[Docket No. FAA-2019-0469; Product Identifier 2019-CE-028-AD; Amendment 39-19664; AD 2019-12-09]

Airworthiness Directives; Rockwell Collins, Inc. Flight Display System Application

ACTION: Final rule; request for comments.

Figure 1 to paragraph (g)(3) of this AD; placard location on bezel

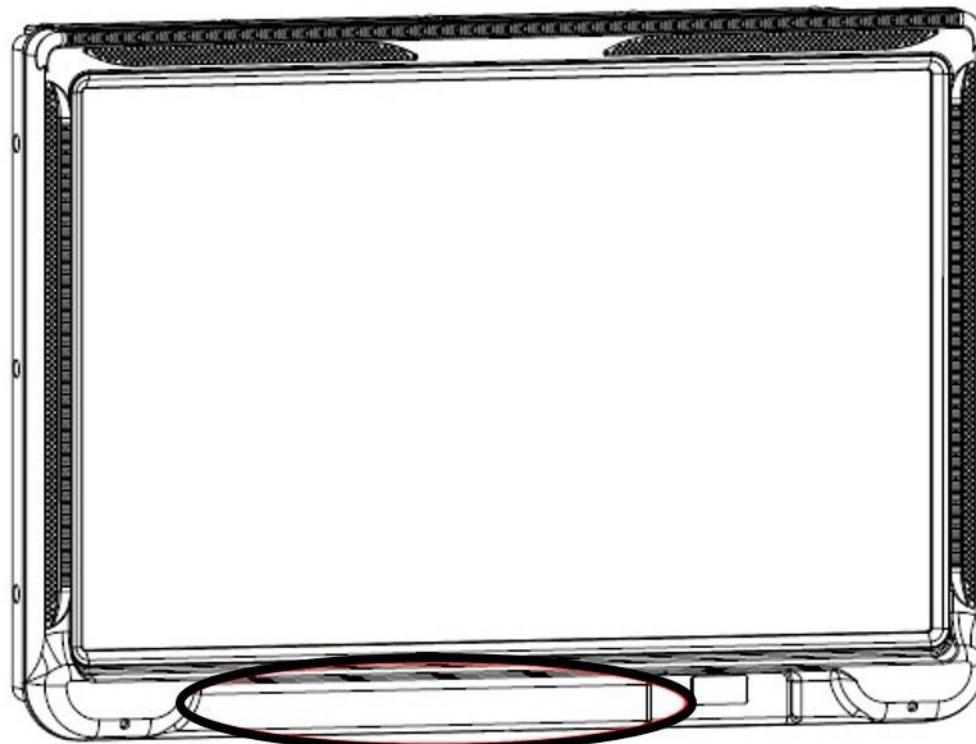
- (2) Fabricate a placard for each aircraft primary flight display, using at least 1/8 inch letters, with the following text: TCAS Flight Ops – TA Only mode (TA/RA mode prohibited).
- (3) Install the placard on the bottom of each aircraft primary flight display bezel in the area depicted in figure 1 to paragraph (g)(3) of this AD.
